ULPOWER AERO ENGINES N.V.

SERVICE BULLETIN

Service Bulletin No. 2019-02

SUBJECT: By-pass orifice between fuel supply line and fuel return line

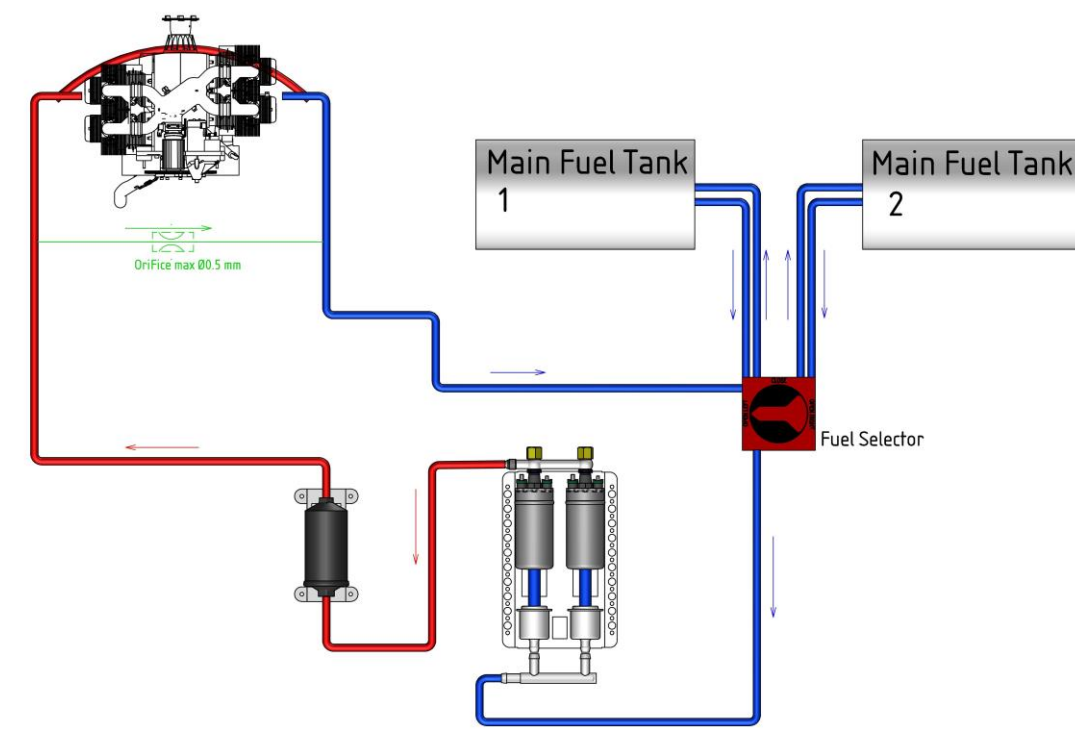
Installing a restricted by-pass fuel line orifice between the pressurized fuel supply and the fuel return line may improve engine priming and recovery from air/vapour ingestion.

The bypass orifice allows fuel/air/vapour to flow in small quantities from the supply line on the pressure side of the fuel pump to the low pressure return line, enabling in many cases a much quicker return to normal engine operations.

Use an orifice of min 0.1mm to max. 0.5 mm diameter. Install in accordance with general rules applying to fuel related installations.

injector WITH integrated by-pass.

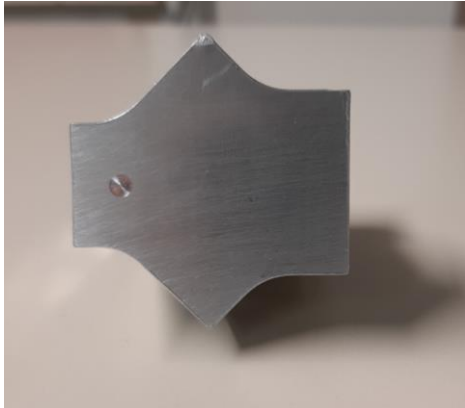
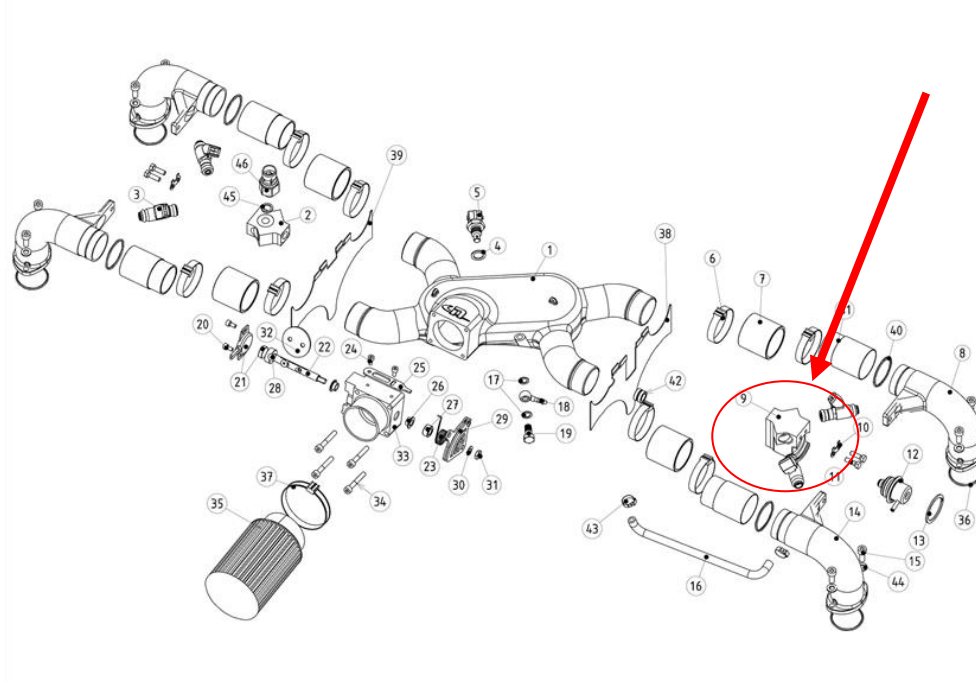
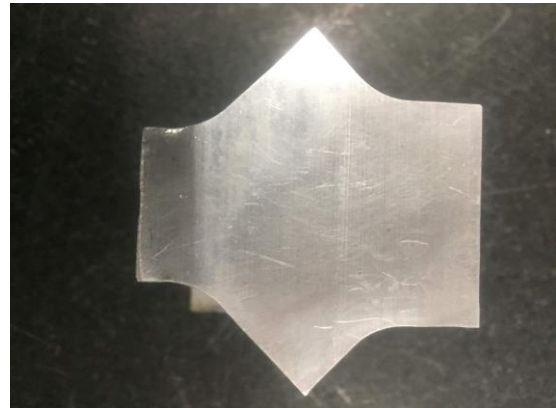
As part of our continuous development and devotion to our concept “Easy to install”, ULPOWER has designed a built-in by-pass solution which will be installed as standard equipment on all new engines with a serial number above 191401 (May 2019).

NOTE: If installing an engine with the new integrated bypass (identified by a mark “o” on the top of the restrictor) it would not be appropriate to use an external restrictor in addition as it may reduce fuel pressure over the rail.

The integrated by-pass solution (K1100001 – Integrated by-pass kit for UL260/350 - 87 EUR) (K1100002 – Integrated by-pass kit for UL390/520 - 93 EUR) may also be retro-fitted on older engines. A procedure can be downloaded from <http://ulpower.news/new-feature-on-ulpower-engines-integrated-by-pass-unit>, our website for tutorials, video's, people stories, events, etc...
